UNITED STATES PATENT AND TRADEMARK OFFICE

APPLICATION NO.	FILING DATE	FIRST NAMED INVENTOR	ATTORNEY DOCKET NO.	CONFIRMATION NO.
10/777,974	02/12/2004	Pete Balsells	3007	7432

Office Action Summary

DETAILED ACTION

FIG. 7C.

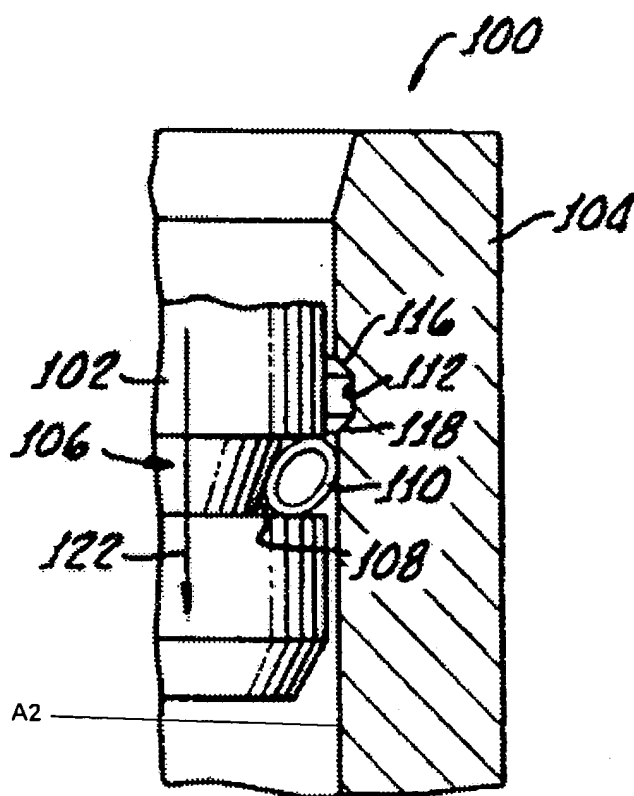
Claims 1-7 and 10-15 are rejected under 35 U.S.C. 102(b) as being anticipated by Balsells, 5,411,348 (see marked-up attachment).

Regarding claim 1, Balsells discloses, in Figure 7c, Balsells discloses a spring holding connector comprising a housing **104**, a shaft **102**, and a circular spring **110**.

The housing **104** has a bore **A2** therethrough. The shaft **102** is rotatably and slidably received in the bore **A2**. The shaft **102** has a circular groove **106**. The spring **110** is disposed in the groove **106**. The groove **106** is sized and shaped.

Regarding claim 7, the groove **106** includes an uneven bottom. Applicant should note that the tapered bottom is uneven relative to the groove.

Regarding claim 13, the groove **106** has a tapered bottom **108**.

Regarding claims 10 and 14, the spring **110** is an axial spring having a back angle at an inside diameter of the loops of the spring **110** and a front angle on an outside diameter of the loops (See Figs. 19b, 20b, 21b).
